SUBJECT: ISSUANCE OF AMENDMENTS (TAC NOS. M96898, M96899, M96900 AND M96901)

The amendments would update the pressure-temperature (P-T) curves contained in the Dresden and Quad Cities Technical Specifications to 22 Effective Full Power Years (EFPYs).

ATTACHMENT TO LICENSE AMENDMENT NOS. 153 AND 148

SAFETY EVALUATION BY THE OFFICE OF NUCLEAR REACTOR REGULATION  
RELATED TO AMENDMENT NO. 153 TO FACILITY OPERATING LICENSE NO. DPR-19,  
AMENDMENT NO. 148 TO FACILITY OPERATING LICENSE NO. DPR-25,  
AMENDMENT NO. 172 TO FACILITY OPERATING LICENSE NO. DPR-29  
AND AMENDMENT NO. 168 TO FACILITY OPERATING LICENSE NO. DPR-30  
COMMONWEALTH EDISON COMPANY AND  
MIDAMERICAN ENERGY COMPANY  
DRESDEN NUCLEAR POWER STATION, UNITS 2 AND 3, AND  
QUAD CITIES NUCLEAR POWER STATION, UNITS 1 AND 2  
DOCKET NOS. 50-237, 50-249, 50-254 AND 50-265

FIGURE 3.6.K-3

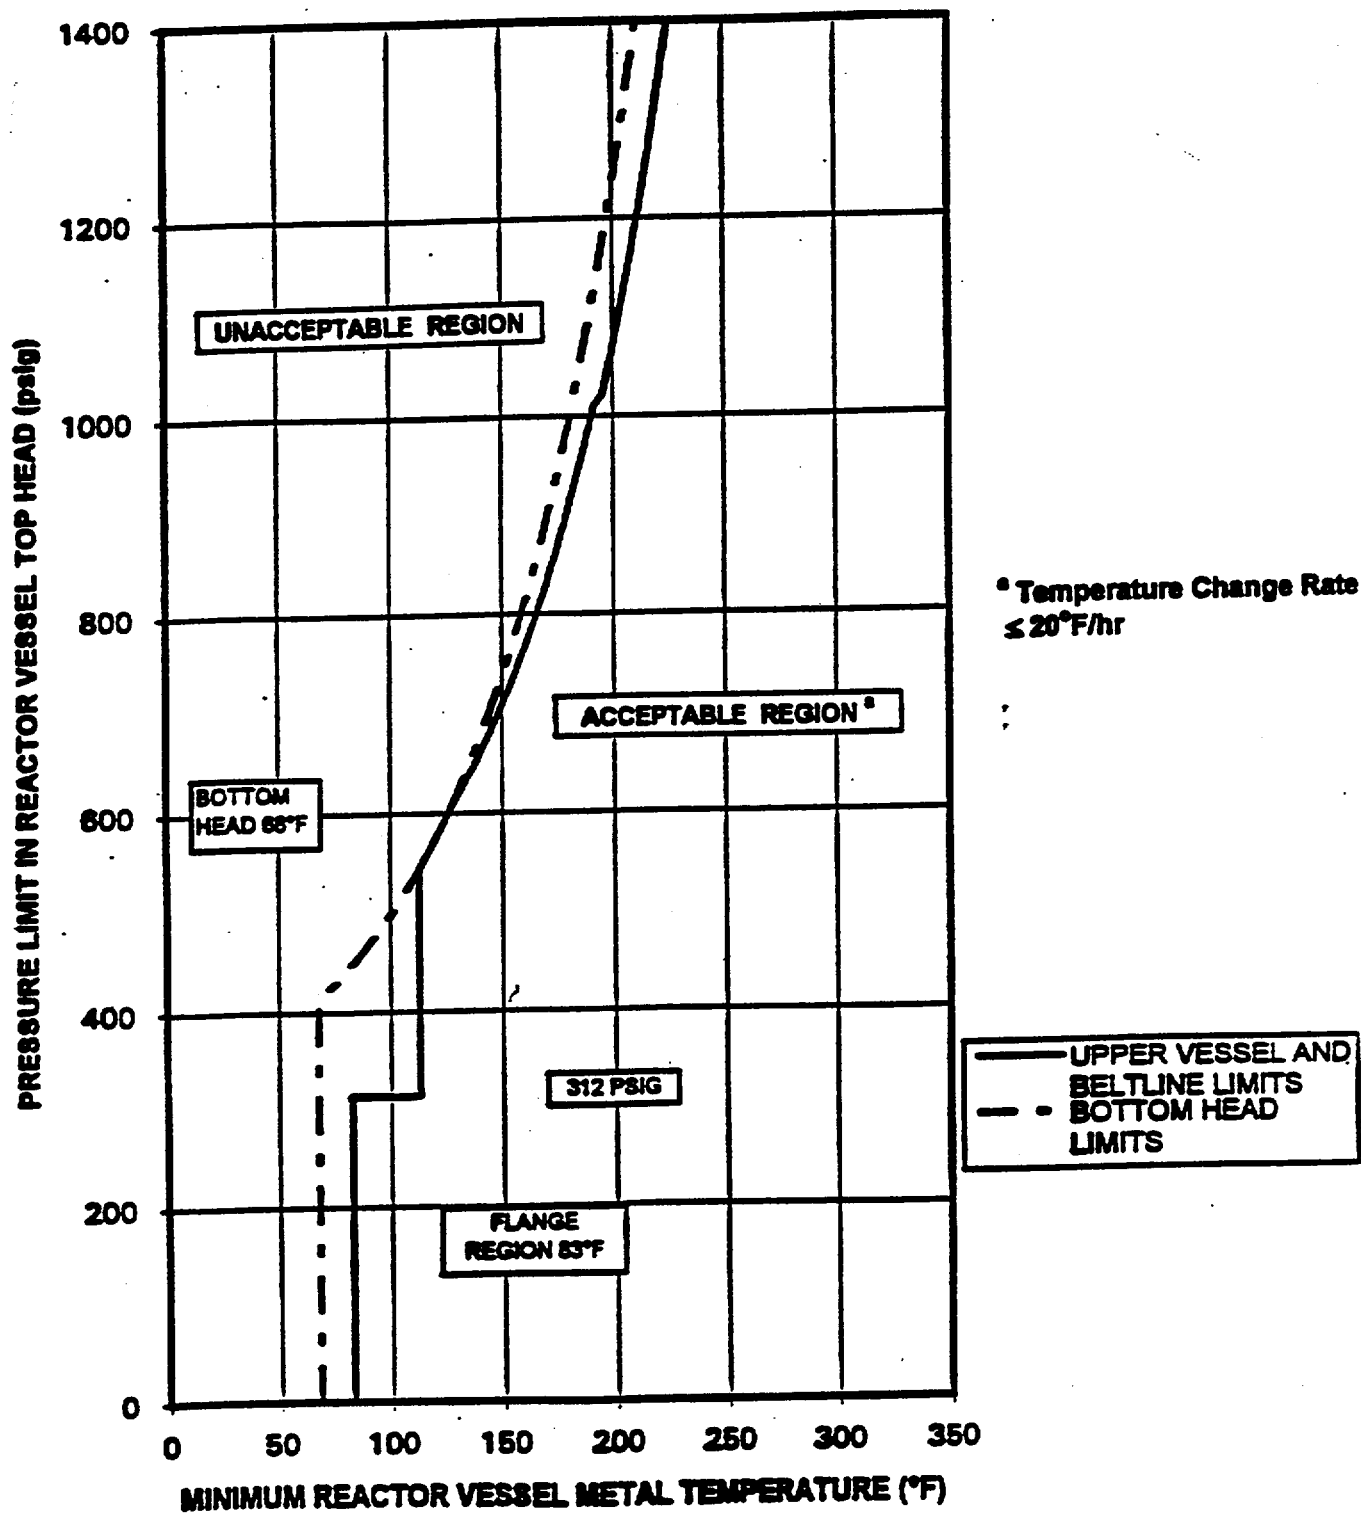
As indicated in Figure 3.6.K-1 through 3.6.K-3 for pressure testing, the minimum metal temperature of the reactor vessel shell is 83°F for reactor pressures less than 312 psig. This 83°F minimum boltup temperature is based on a  $RT_{NDT}$  of 23°F for the electroslog weld immediately below the vessel flange and a 60°F conservatism required by the original ASME Code of construction. The bottom head region limit is established as 68°F, based on moderator temperature assumptions for shutdown margin analyses. At reactor pressures greater than 312 psig, the minimum vessel metal temperature is established as 113°F. The 113°F minimum temperature is based on a closure flange region  $RT_{NDT}$  of 23°F and a 90°F conservatism required by 10CFR Part 50 Appendix G. Beltline curves as a function of vessel exposure for 18, 20 and 22 effective full power years (EFPY) are presented to allow the use of the appropriate curve up to 22 EFPY of operation.

FIGURE 3.6.K-4

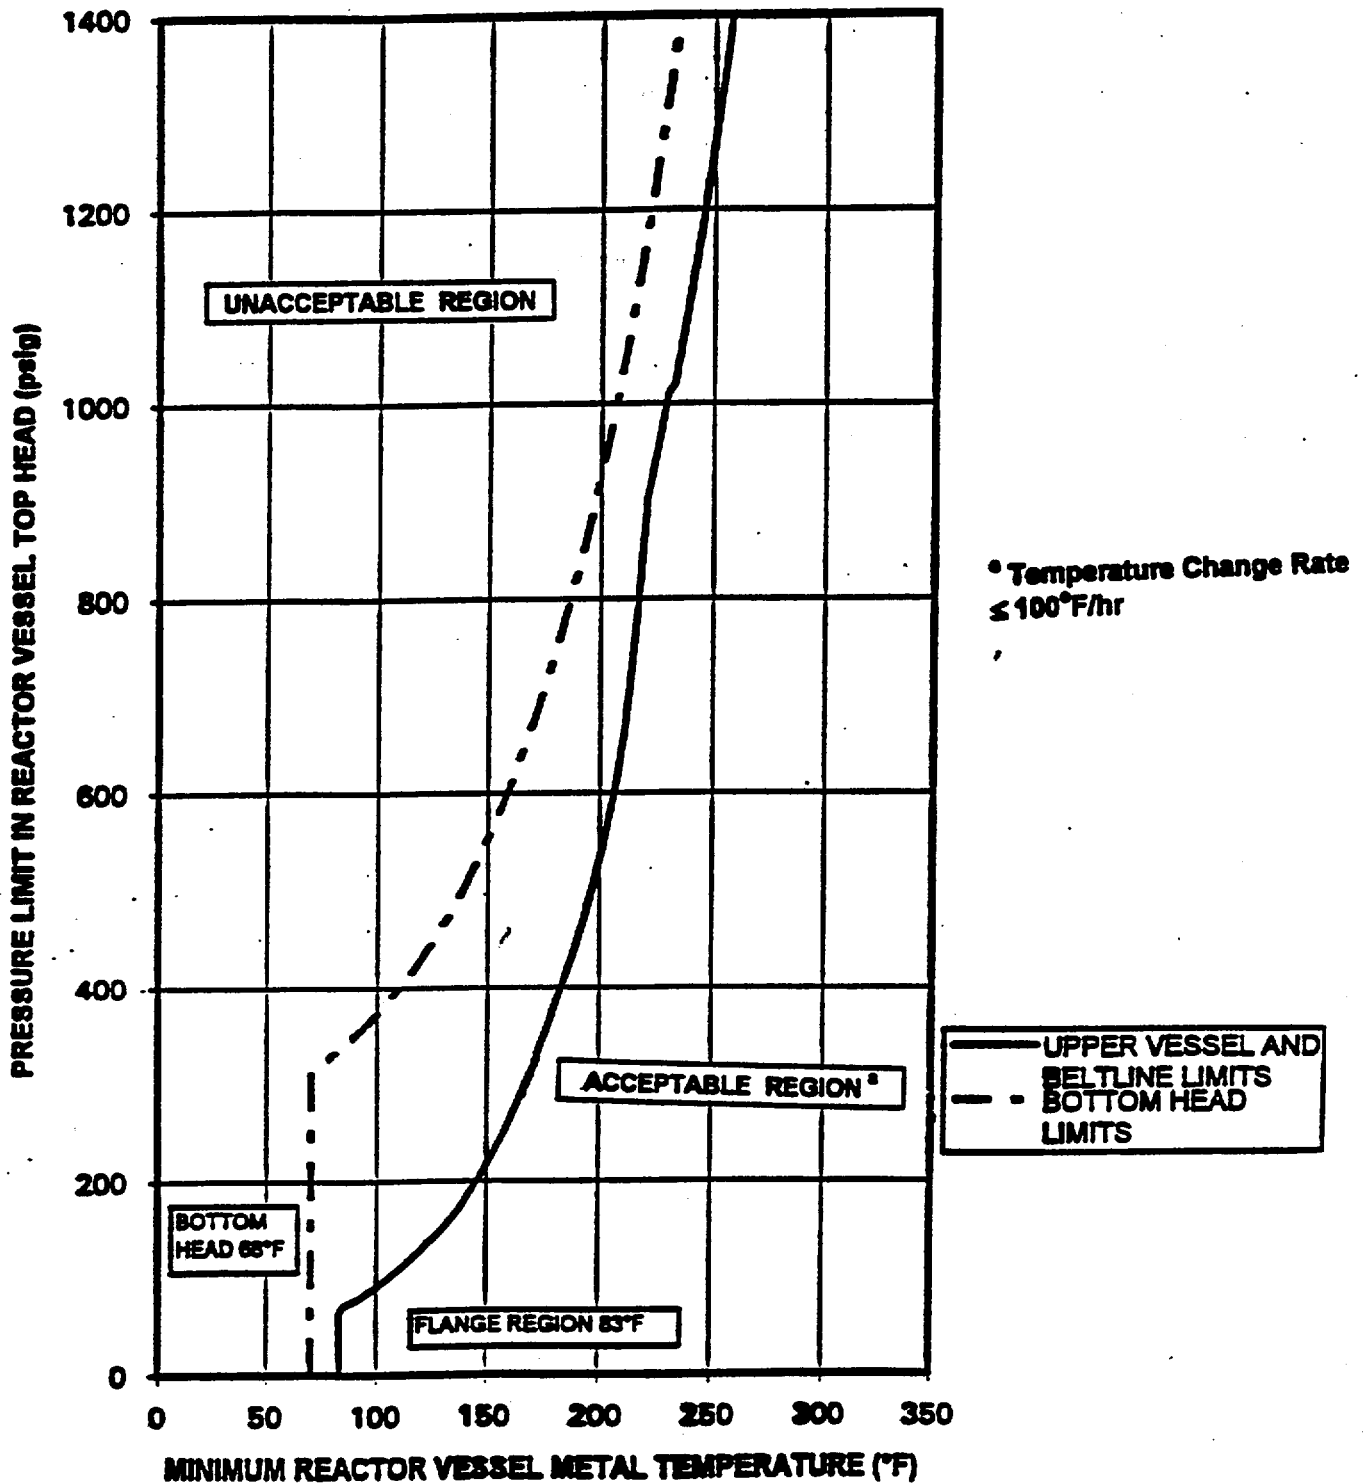
Figure 3.6.K-4 applies during heatups with non-nuclear heat (e.g., recirculation pump heat) and during cooldowns when the reactor is not critical (e.g., following a scram). The curve provides the minimum reactor vessel metal temperatures based on the most limiting vessel stress. The maximum heatup/cooldown rate of 100°F/hour is applicable.

FIGURE 3.6.K-5

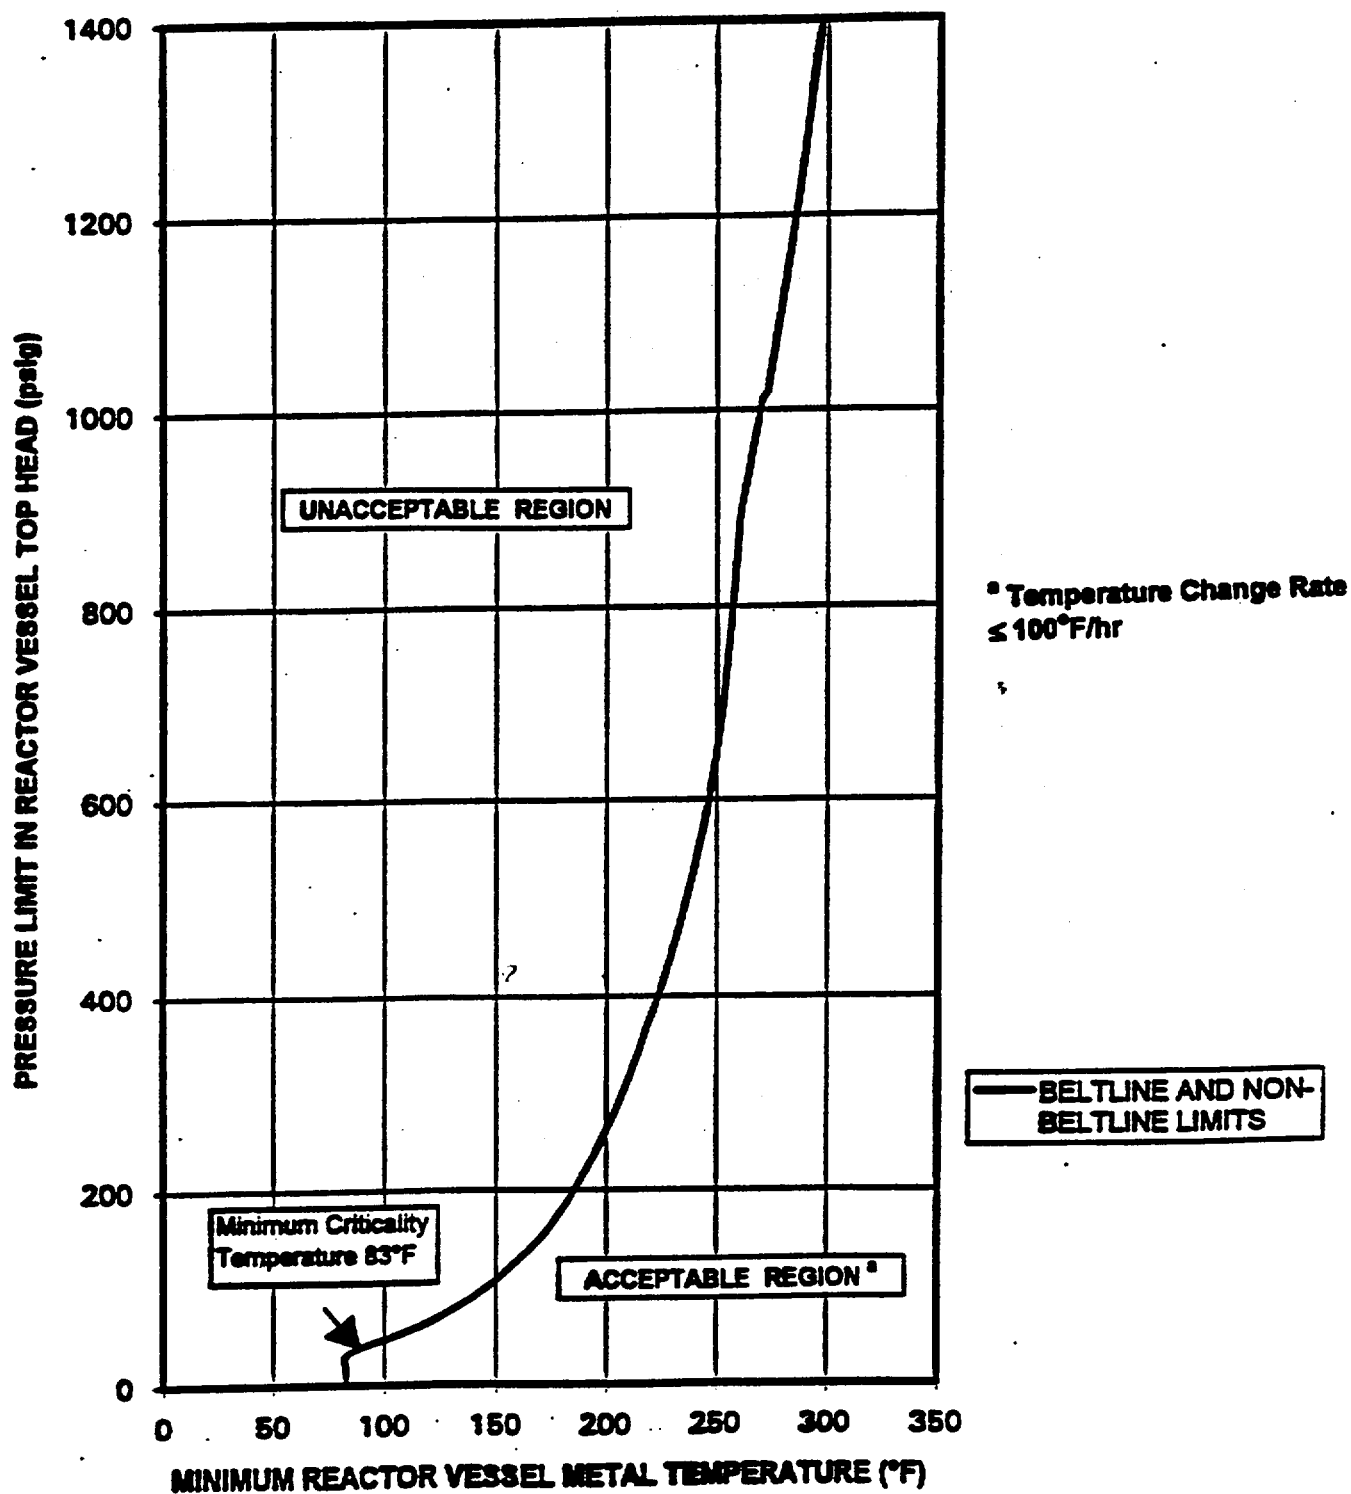
The core critical operation curve shown in Figure 3.6.K-5, is generated in accordance with 10CFR Part 50 Appendix G which requires core critical pressure-temperature limits to be 40°F above any pressure testing or non-nuclear heatup/cooldown limits. Since Figure 3.6.K-4 is more limiting, Figure 3.6.K-5 is Figure 3.6.K-4 plus 40°F. The maximum heatup/cooldown rate of 100°F/hour is applicable.

FIGURE 3.6.K-3

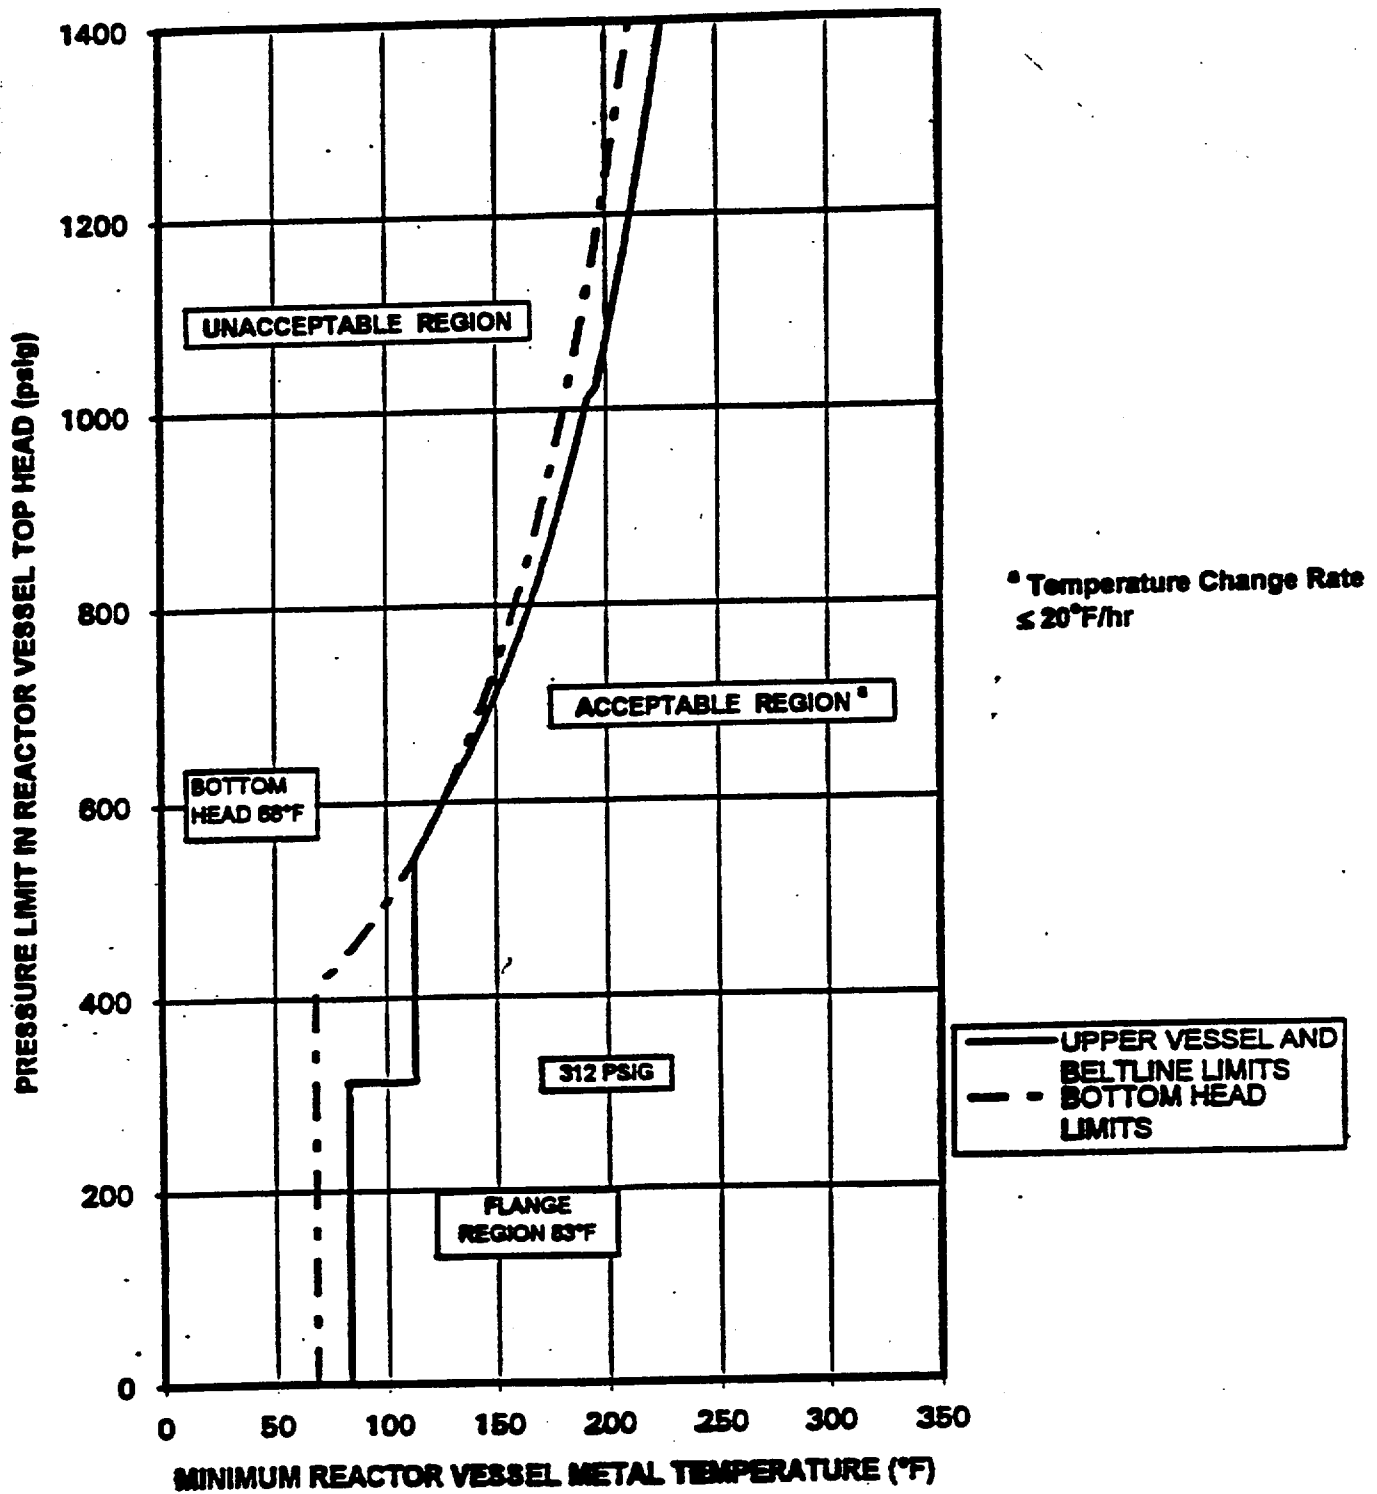
As indicated in Figure 3.6.K-1 through 3.6.K-3 for pressure testing, the minimum metal temperature of the reactor vessel shell is 83°F for reactor pressures less than 312 psig. This 83°F minimum boltup temperature is based on a  $RT_{NDT}$  of 23°F for the electrosag weld immediately below the vessel flange and a 60°F conservatism required by the original ASME Code of construction. The bottom head region limit is established as 68°F, based on moderator temperature assumptions for shutdown margin analyses. At reactor pressures greater than 312 psig, the minimum vessel metal temperature is established as 113°F. The 113°F minimum temperature is based on a closure flange region  $RT_{NDT}$  of 23°F and a 90°F conservatism required by 10CFR Part 50 Appendix G. Beltline curves as a function of vessel exposure for 18, 20 and 22 effective full power years (EFPY) are presented to allow the use of the appropriate curve up to 22 EFPY of operation.

FIGURE 3.6.K-4

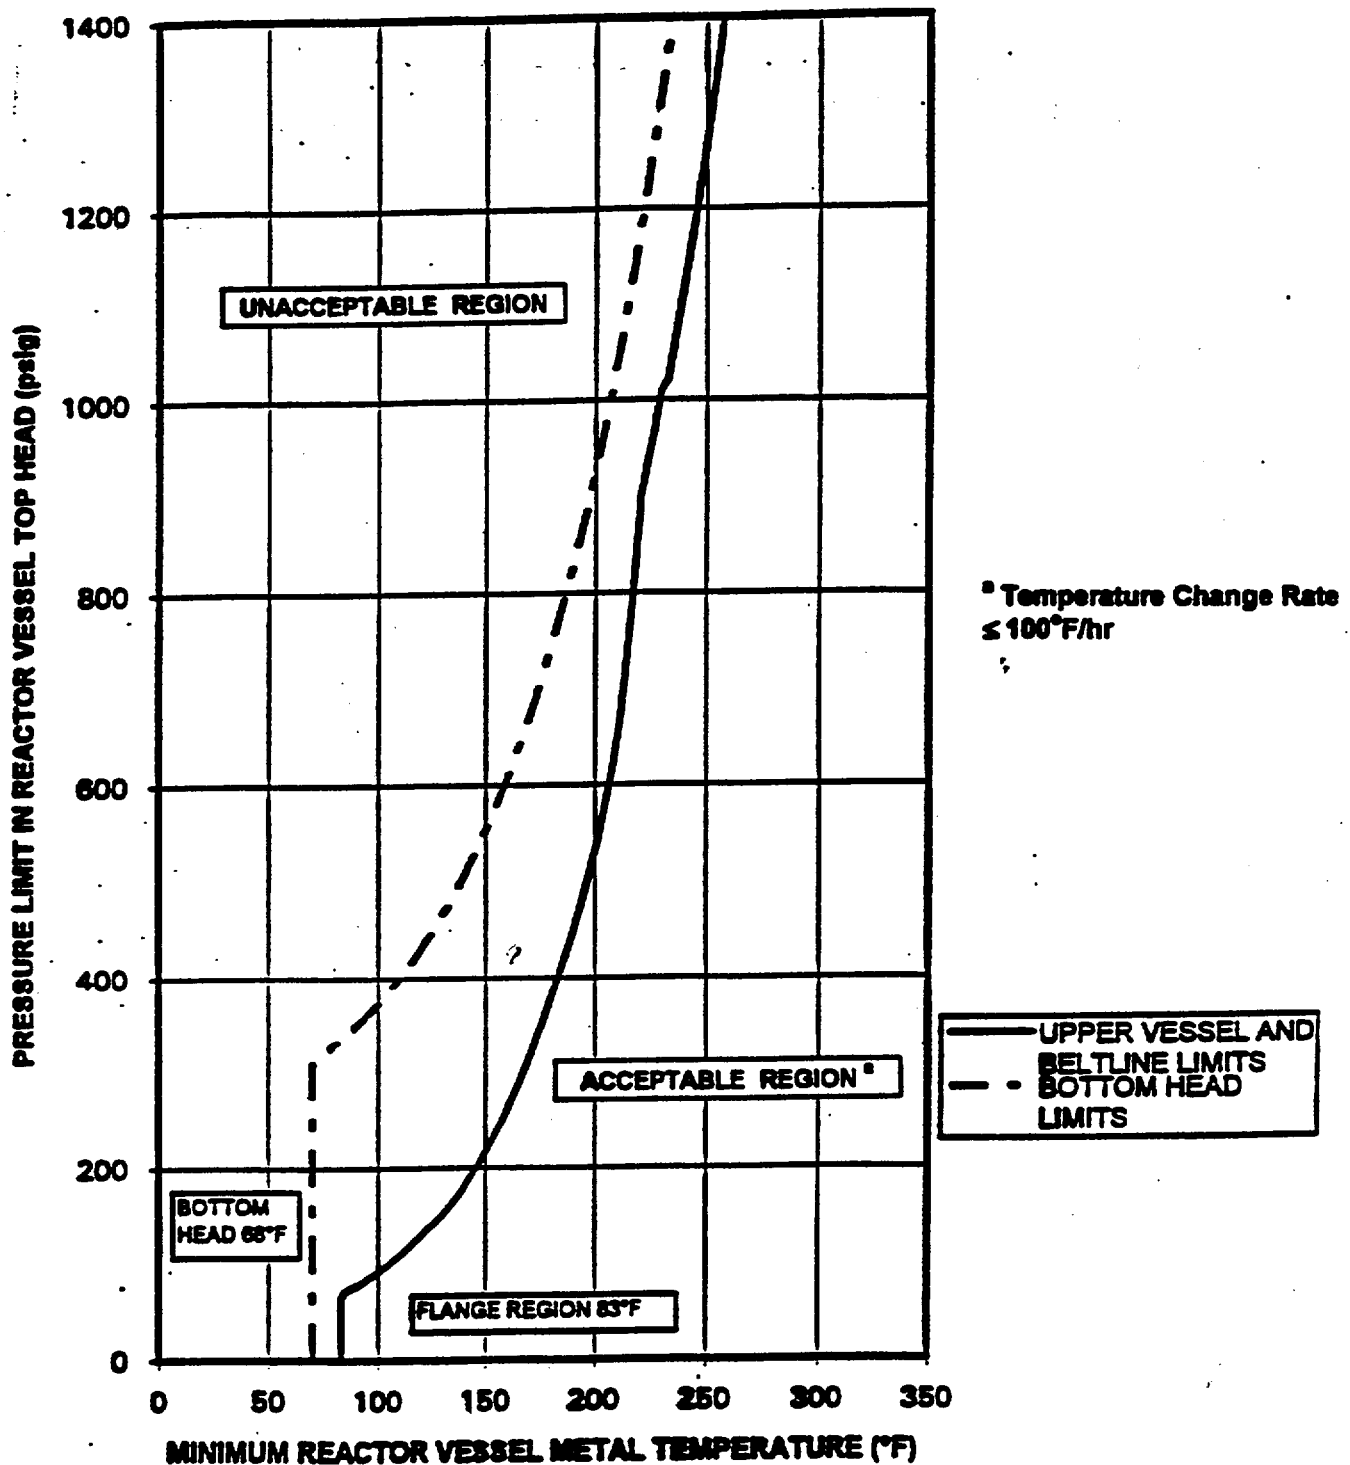
Figure 3.6.K-4 applies during heatups with non-nuclear heat (e.g., recirculation pump heat) and during cooldowns when the reactor is not critical (e.g., following a scram). The curve provides the minimum reactor vessel metal temperatures based on the most limiting vessel stress. The maximum heatup/cooldown rate of 100°F/hour is applicable.
